**ANSTY GARDEN COMMUNITY,**

**DESIGNERS RESPONSE**

**REPORT REF NO. 2207280-R13A**

- 1.6 The following drawing have been prepared to incorporate the findings of the RSA:
- **ACE Drawing 2207280-003G** – Proposed Roundabout Northern Access (A272)

Drawing Title: **PROPOSED ROUNDABOUT NORTHERN ACCESS (A272)**

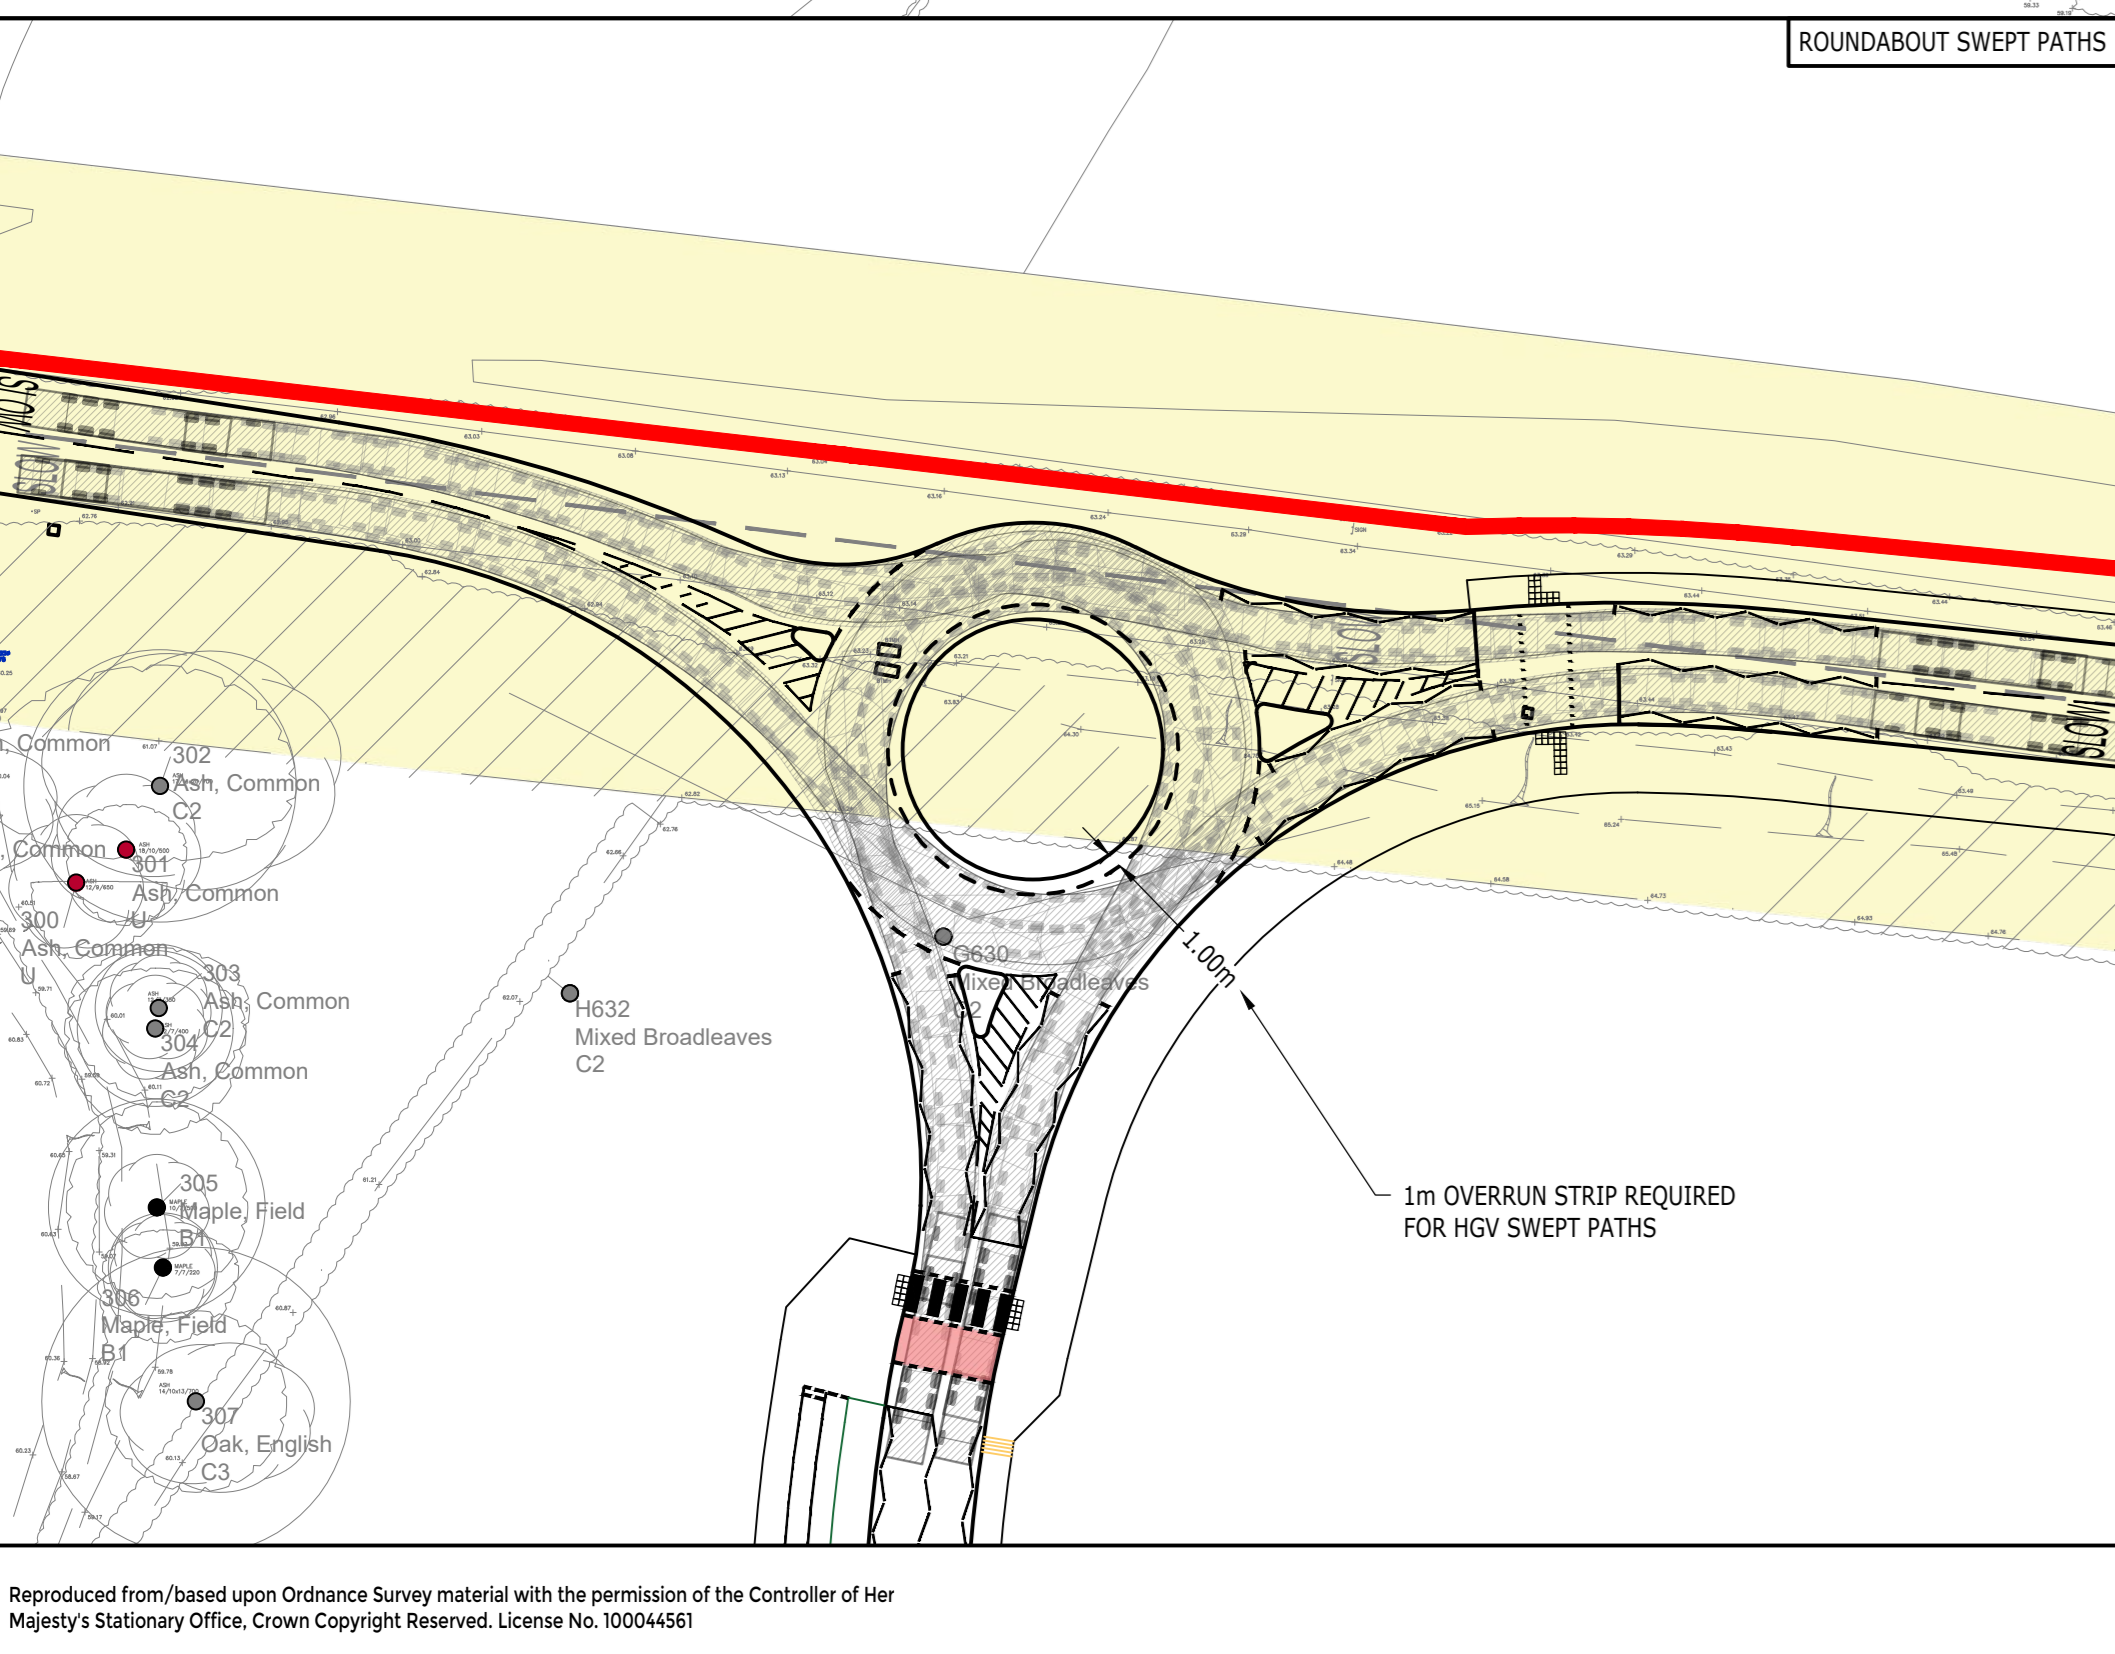
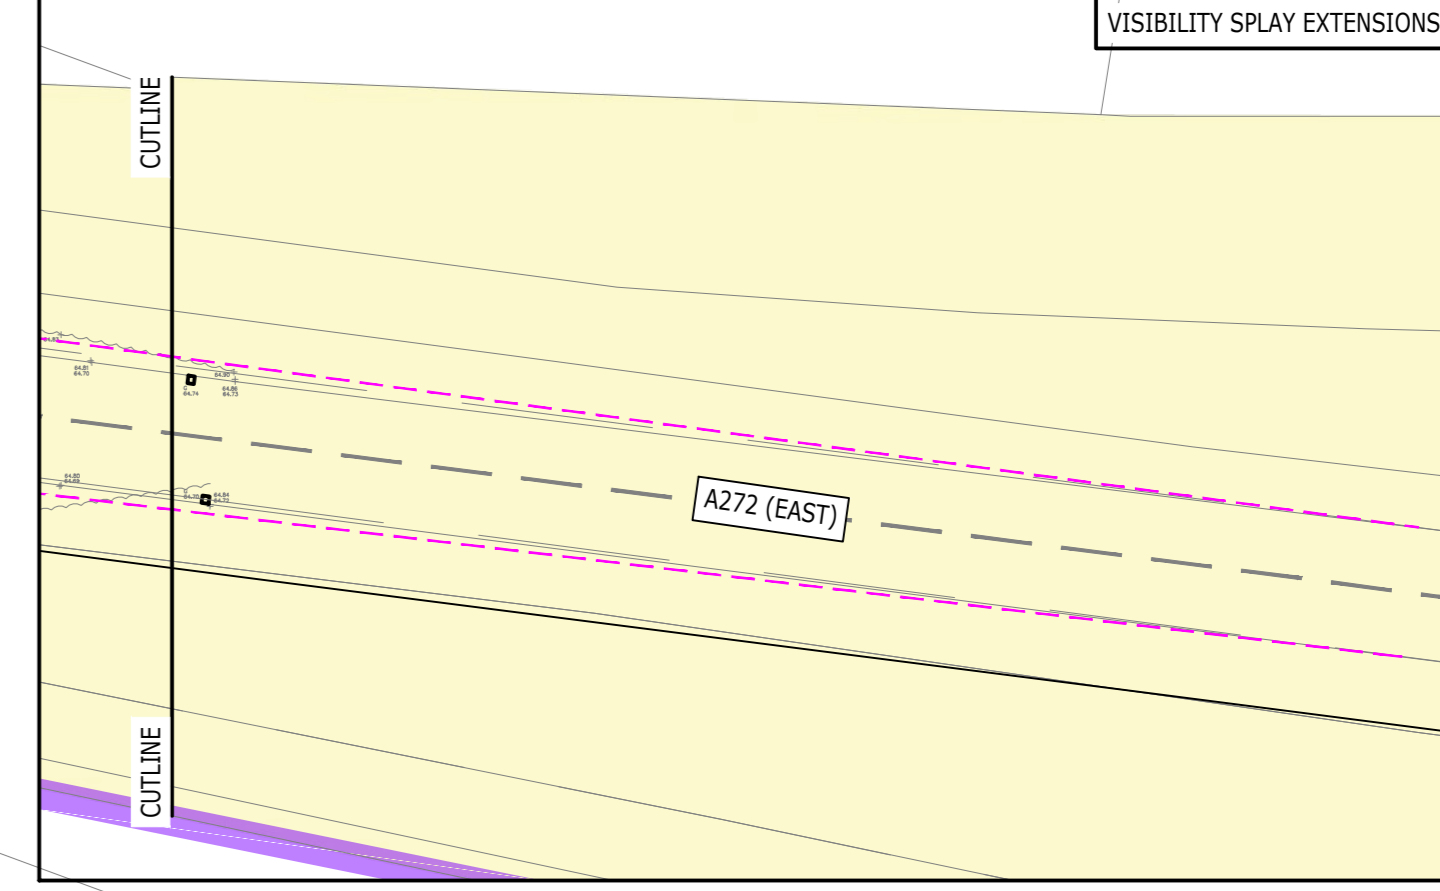
<b>RSA problem</b>	<b>RSA recommendation</b>	<b>Design Organisation response</b>	<b>Overseeing Organisation response</b>	<b>Agreed RSA action</b>
<p>3.1.1 Insufficient construction details could lead to overshoot or rear end shunt collisions.</p> <p>The proposals do not include the introduction of anti-skid surfacing or detail the Polished Stone Value (PSV) to be used on the approaches to the roundabout and surfacing as part of the scheme. Surfacing with an insufficient PSV could lead to overshoot or rear end shunt collisions.</p>	<p>It is recommended that high friction surfacing should be provided on all the approaches to the roundabout and that the PSV of all surfacing should be provided for assessment.</p>	<p>Agree. Details of PSV values and surfacing materials will be provided for Stage 2 Audit.</p>	<p>High friction surfacing should be provided and details of PSV values to be provided at detailed design stage.</p>	<p>High friction surfacing will be provided and details of PSV values to be provided at detailed design stage.</p>

<p>3.1.5 Inappropriate vehicle speeds could lead to could lead to vehicle to pedestrian / cyclist collisions or rear end shunts.</p> <p>A national speed limit currently applies to this</p>	<p>It is recommended that a 30mph speed restriction should be applied to the southern arm of the roundabout.</p>	<p>Agree, the southern arm (development access arm) will be subject to a 20/30mph speed limit as noted on <b>ACE Drawing 2207280-003G</b>.</p> <p>Signage to be in accordance with TSRGD and LTN1/20</p>	<p>A 20 or 30mph speed limit should be applied to the southern arm.</p>	<p>A 20 or 30mph speed limit will be applied to the southern arm.</p>

<p>3.2.1 Approaches to the proposed roundabout.</p> <p>Stopping Sight Distances (SSD) have been provided for assessment and at 215m are acceptable for the current national speed limit. An insufficient SSD may increase the risk of junction related or shunt type collisions at the roundabout and so the 120m SSD, which is commensurate with a 40mph design speed, should only be incorporated if a reduced speed limit of 40mph is introduced.</p>	<p>It is recommended that the SSD should be commensurate with the design speeds, in addition at pedestrian crossing points pedestrian/ vehicle intervisibility splays should also be commensurate with the design speeds.</p>	<p>Agreed. As shown on <b>ACE Drawing 2207280-003G</b> 215m (posted speed) visibility splays have been shown.</p> <p>A 120m visibility splay has also been shown should WSCC consider a change to the posted speed limit.</p> <p>Vegetation to be trimmed and cut back to keep visibility splays clear has also been noted on the drawing.</p> <p>Further details will also be provided for Stage 2 Audit.</p>	<p>Visibility splays to be provided in line with future posted speed limit.</p>	<p>Visibility splays to be provided in line with future posted speed limit.</p>

Plan attached showing the locations of the problems identified as part of this audit (location numbers refer to paragraph numbers in the report).

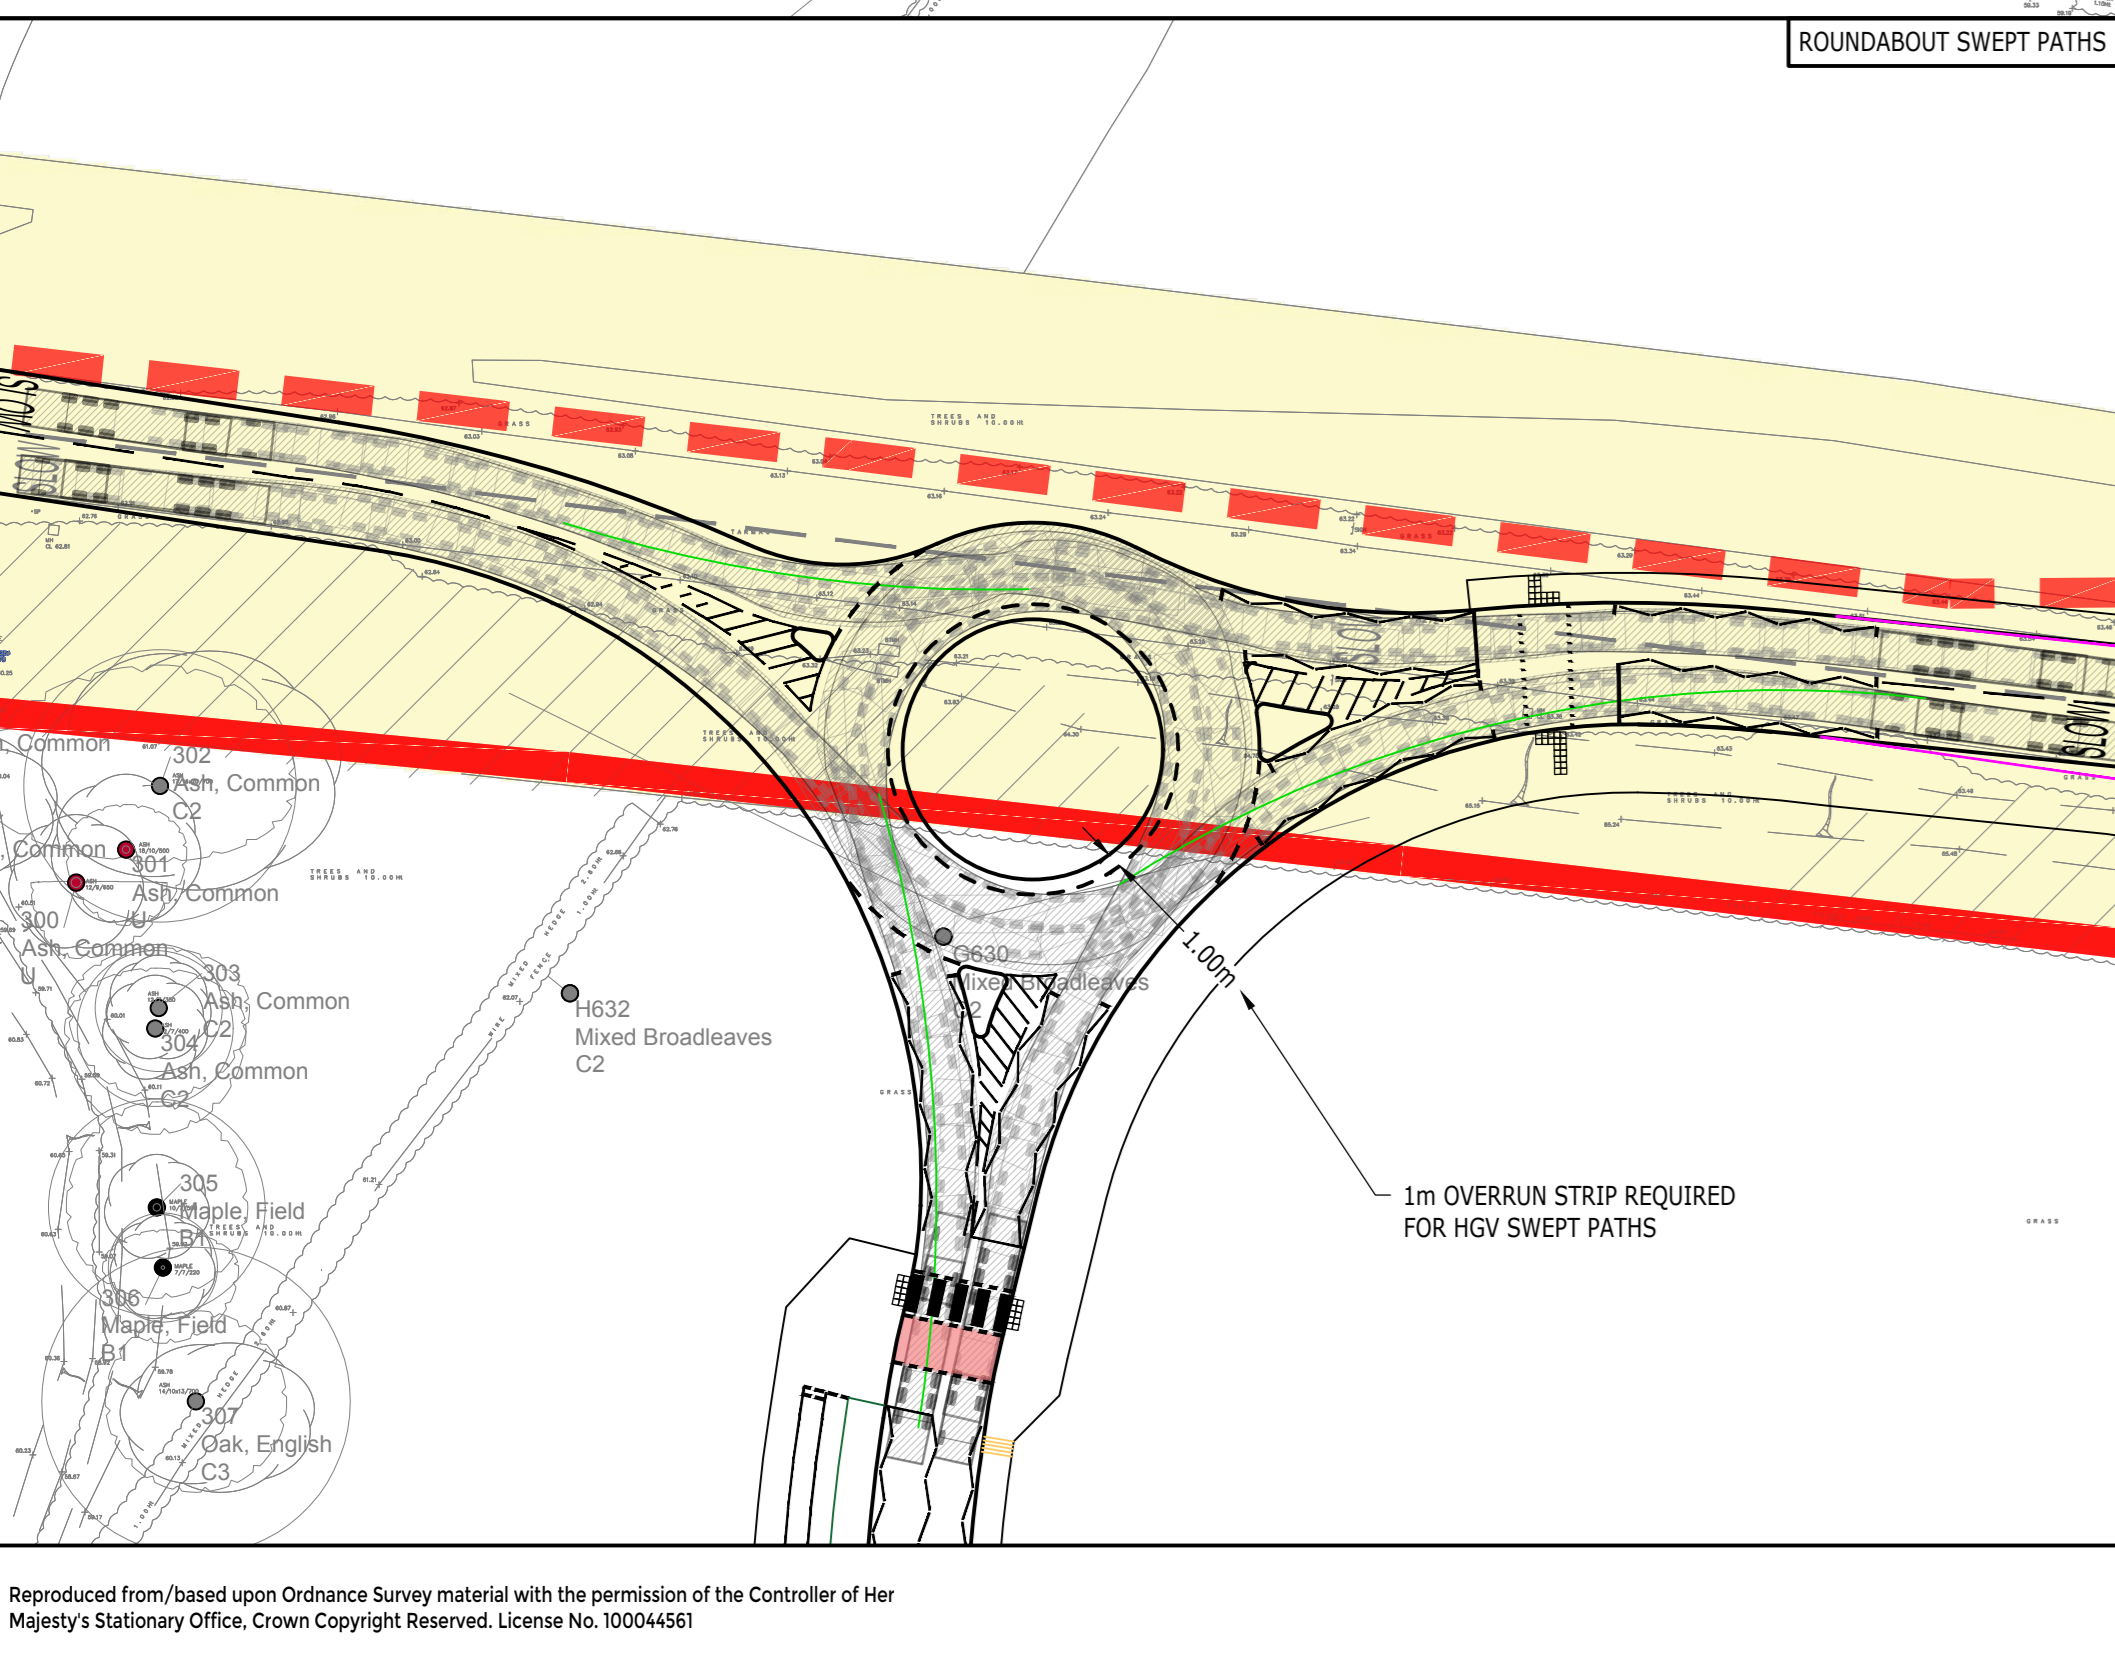
The proposals do not include the introduction of anti-skid surfacing or detail the Polished Stone Value (PSV) to be used on the approaches to the roundabout and surfacing as part of the scheme. Surfacing with an insufficient PSV could lead to overshoot or rear end shunt collisions.

Kerblines are being amended as part of these proposals, where no details of carriageway drainage have been provided for assessment; ponding on the carriageway or water moving across the carriageway at junctions or bends could lead to loss of control collisions, particularly in wet / icy conditions.

A national speed limit currently applies to this section of the A272 where the proposed speed limit on the southern arm is unknown. This could lead to inappropriate vehicle speeds approaching the Parallel crossing, which should not be installed on roads with an 85<sup>th</sup> percentile speed of 35 mph or above without speed reducing measures to slow traffic.

Stopping Sight Distances (SSD) have been provided for assessment and at 215m are acceptable for the current national speed limit. An insufficient SSD may increase the risk of junction related or shunt type collisions at the roundabout and so the 120m SSD, which is commensurate with a 40mph design speed, should only be incorporated if a reduced speed limit of 40mph is introduced.

On the westbound approach to the roundabout there is concern that the SSD could pass over non-highway land. Vegetation or landscaping features in this splay could restrict visibility, where insufficient visibility may increase the risk of junction related or shunt type collisions at the roundabout.
